**BEFORE THE BOARD OF PATENT APPEALS
AND INTERFERENCES**

Application Number: 10/531,622
Filing Date: April 14, 2005
Appellant(s): FOELL ET AL.

EXAMINER'S ANSWER

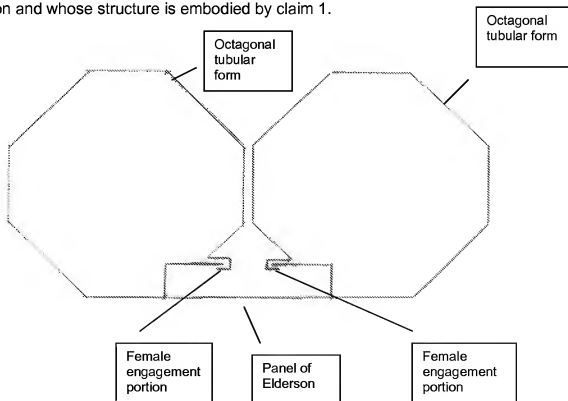
In any event, one can see from the examiner’s rendition illustrated below that the “panel” of Elderson can indeed be used with and engage respective matching female engagement portions of any two elongated octagonal form elements. See also, appellant’s embodiment of Figure 35 which has the same structural characteristics as Elderson and whose structure is embodied by claim 1.
